MEMORANDUM TO: PD IV-1 File

SUBJECT: STEAM GENERATOR INSPECTION RESULTS, OCTOBER 1998, SOUTH TEXAS PROJECT, UNIT 2

NRC PHONE DISCUSSION – 2RE06 STEAM GENERATOR TUBE INSPECTION RESULTS OCTOBER 1998

ATTACHMENT 2

Unit Two Primary and Secondary Tritium and Leak Rate

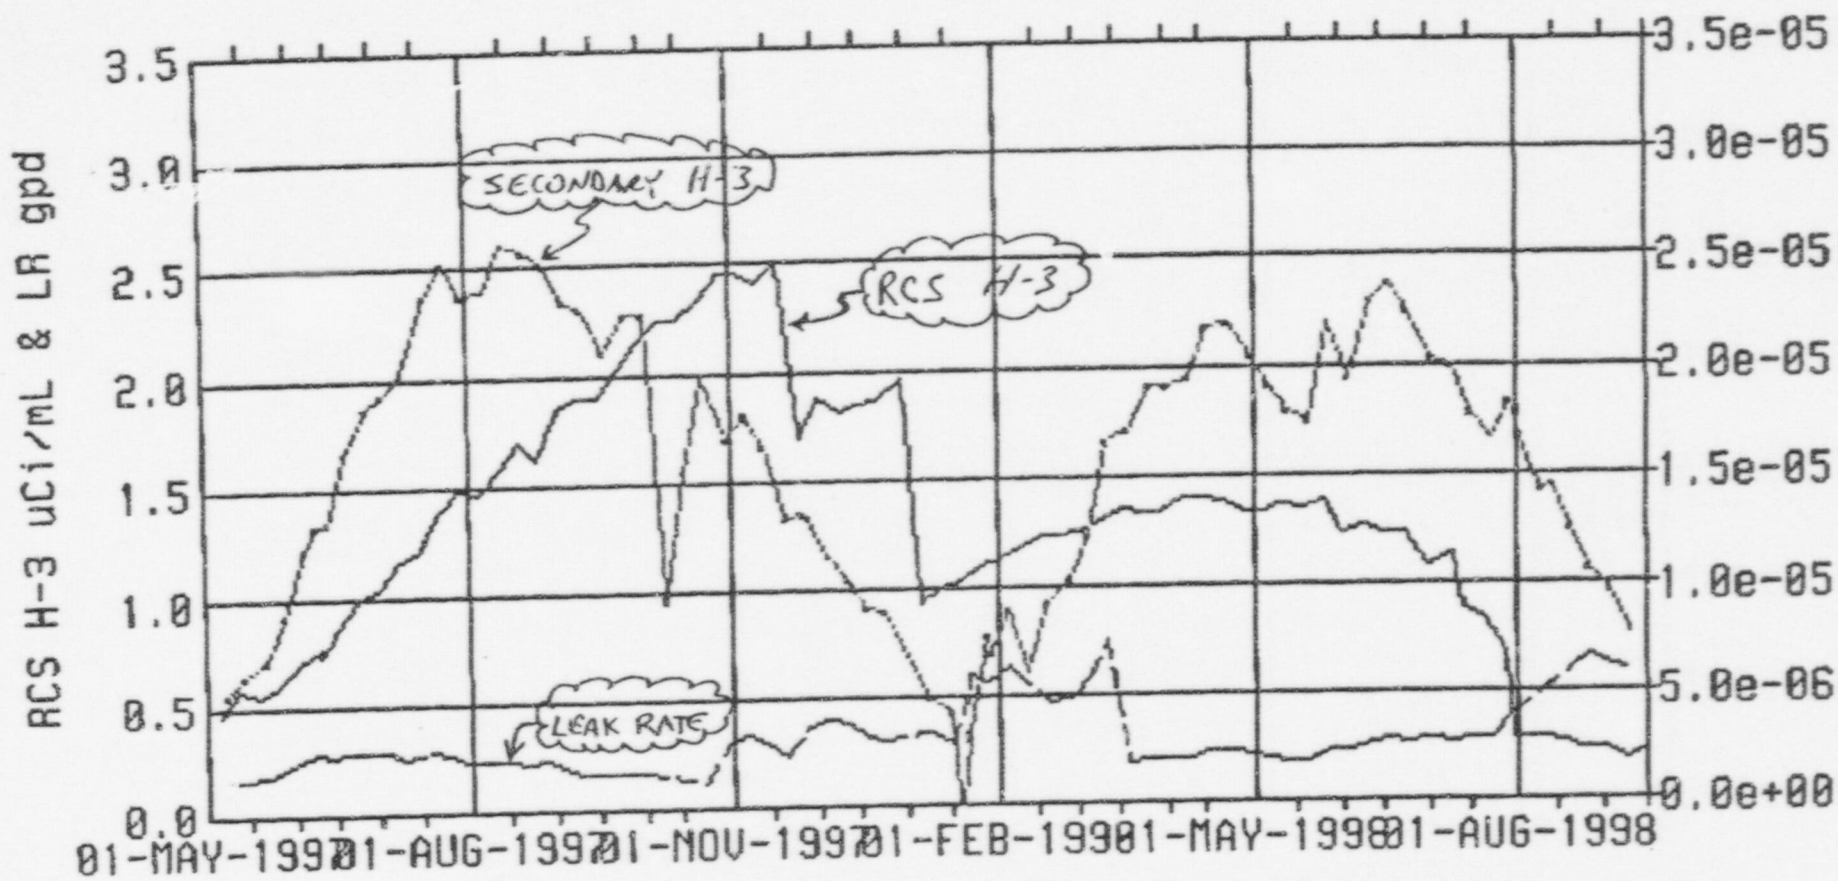
1. Primary to Secondary leakage prior to shutdown.

STP 2RE06 – Leak rate prior to shutdown was a fraction of a gallon per day. Calculated leak rate with with stable tritium concentration in the primary was ~0.25 gpd, but never exceeded ~0.8 gpd during the cycle. See attached graph.
